Audible buzz heard from chassis with CA-D200, AMP2 and AMP5

Service Notice # 0015

Release date: April 9, 2015

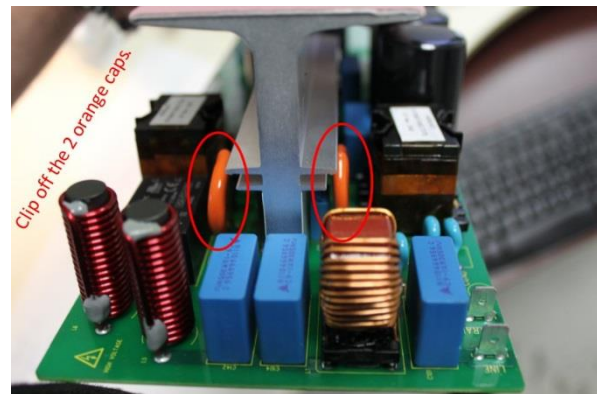
Orange caps to be removed are found in

CA-D200 SN#2260785 and lower, AMP2 SN#2220929 and lower and AMP5 SN#2230762 and lower

Inductors that may require silicone mod are found in

CA-D200 SN#2260785 and lower, AMP2 SN#2220929 and lower and AMP5 SN#2230762 and lower

1. Unplug amplifier from AC outlet and let sit for 15 minutes to let the capacitors discharge. This is critical for safety since the power supply involves high DC voltages.

2. On power supply board R8601, clip the 2 orange capacitors (C54 & C63) with appropriate cutters.

3. Put cover back on and check to see if the noise is still present. If it is, there could be an issue with vibrating inductors on Aux power supply board R8602 (CA-D200, AMP2) or R8702 (AMP5).

Step 1) Locate inductors

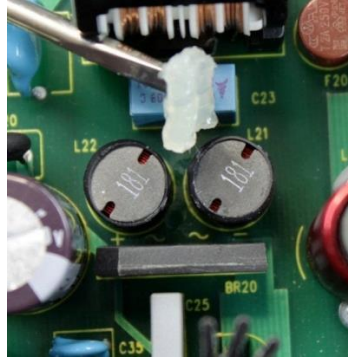
Some AMP2/CA-D200's will already have silicone applied but it may be insufficient. If this is the case, carefully remove the silicone with a small flat blade screwdriver or similar tool. Follow steps 1 & 2. Add silicone around L202 and L203 of R8602 (AUX power supply). The silicone should flood the area and make contact with the bridge rectifier (BR201) and the blue capacitor (C202) that are located on either side of the two inductors. Follow steps 3 through 5.

Step 1) Locate inductors

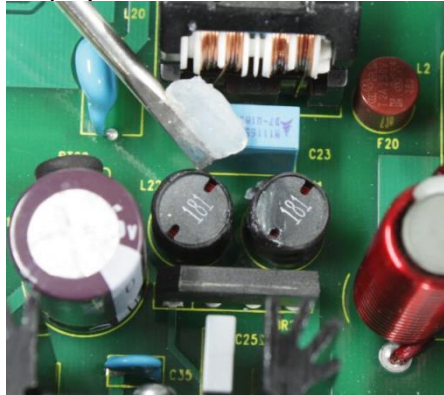
Some AMP5 amplifiers will already have silicone applied but it may be insufficient. If this is the case, carefully remove the silicone with a small flat blade screwdriver or similar tool. Follow steps 1 & 2. Add silicone between L21 and L22 of R8702 (AUX power supply board). The silicone should flood the area and make contact with the bridge rectifier (BR20) and the blue capacitor (C21) that are located on either side of the two inductors. Follow steps 3 through 5.
